**From:** Jones, William V, EMNRD  
**Sent:** Friday, April 10, 2015 6:41 PM  
**To:** 'Swartz, Paul'; 'efernand@blm.gov'  
**Cc:** Goetze, Phillip, EMNRD; Wade, Gabriel, EMNRD  
**Subject:** OWL's: Brininstool Well No. 1 API: 30-025-37582 SWD-1364 Bell/Cherry perms from 5223 - 7380

Well: Brininstool - 01

API: 3002537582

**AOR well**  
Well: Mary - 01  
API: 3002525473  
@ Srfce: T23S-R33E, Sec 25, 1980FSL & 1980FEL  
@ M TD: T23S-R33E, Sec 25, 1980FSL & 1980FEL

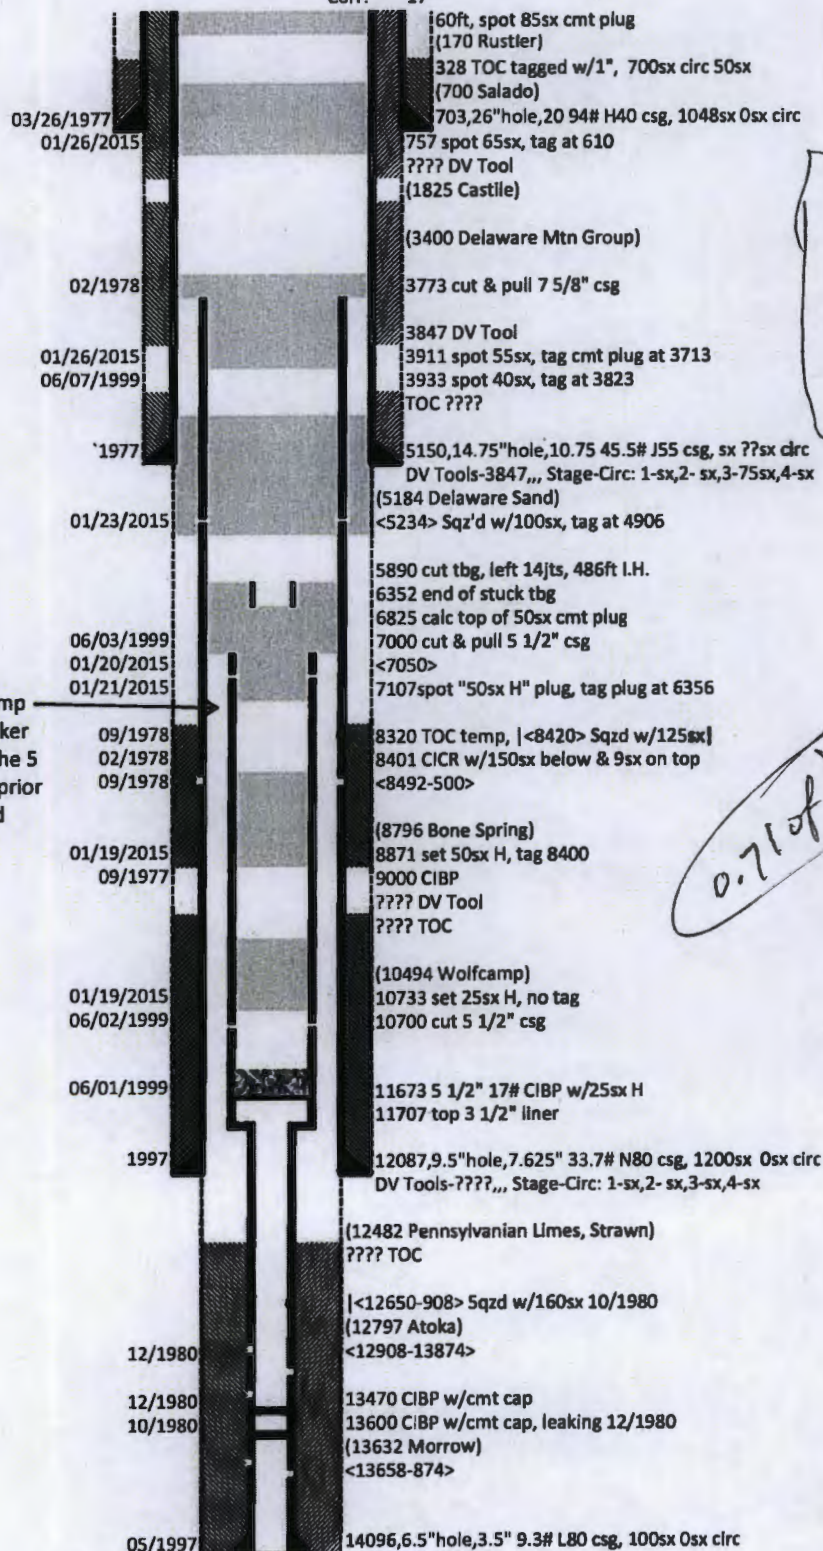
Yes, the offsetting well (30-025-25473) which is located 1866 feet SW of the disposal well looks better now after the squeeze operations.  
Lots of work done on that AOR well early this year.

Please confirm – but it still appears that cement top behind pipe is at 8320 feet and bottom of permitted disposal is at 7380 feet – almost 1000 feet lower than permitted disposal depths and now down into the Brushy Canyon but still above the Bone Spring. So the disposal interval is not confined on the bottom. The older records show that, the outside of this 7-5/8 at this depth may have frac sand in it – or even some cement?

And we may put a note in the file to limit future pressure increases in this well.
